Project	IEEE 802.16 Broadband Wireless Access Working Group < http://ieee802.org/16 >	
Title	Suggested Modifications to AK Caching Solution	
Date Submitted	2006-09-25	
Source(s)	Joe Schumacher Motorola	Voice: +1 847 632 5978 [mailto:j.schumacher@motorola.com]
	Steve Upp Motorola	Voice: +1 847 576 4953 [mailto:Steve.Upp@motorola.com]
	Walter Goulet Motorola	Voice: +1 847 576 7036 [mailto:Walter.Goulet@motorola.com]
	Simon Mizikovsky, Robert Rance, Dan Gal, Peretz Feder Lucent Technologies	Voice: +1 973 386 6348 [mailto:smizikovsky@lucent.com]
	Phillip Barber Huawei, Inc.	Voice: +1 972 365 6314 [mailto:pbarber@huawei.com]
Re:	060925_Suggested modifications to 802.16e to support AK Caching Solution_and_CMAC-0.doc	
Abstract	Modifications are proposed that support the proposed AK Caching Solution without discarding the legacy CMAC calculation mode.	
Purpose	Adoption	
Notice	This document has been prepared to assist IEEE 802.16. It is offered as a basis for discussion and is not binding on the contributing individual(s) or organization(s). The material in this document is subject to change in form and content after further study. The contributor(s) reserve(s) the right to add, amend or w

Figure 130o—HMAC/CMAC/KEK derivation from AK

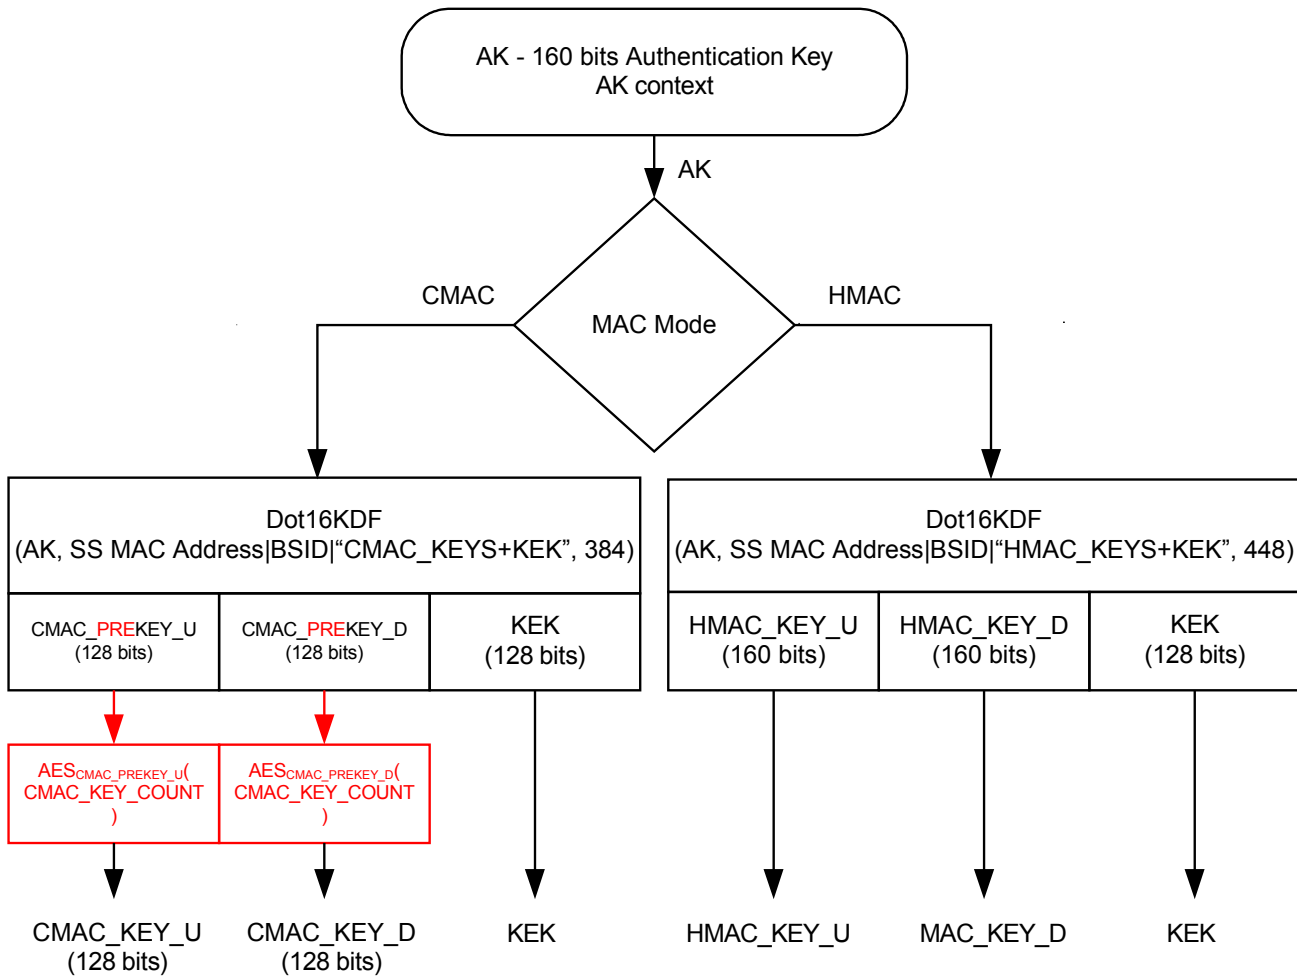
Change 6: Modify CMAC Key derivation figure.

[Please insert the red text and graphics as follows in Figure 130o, page 283 of 802.16e-2005]
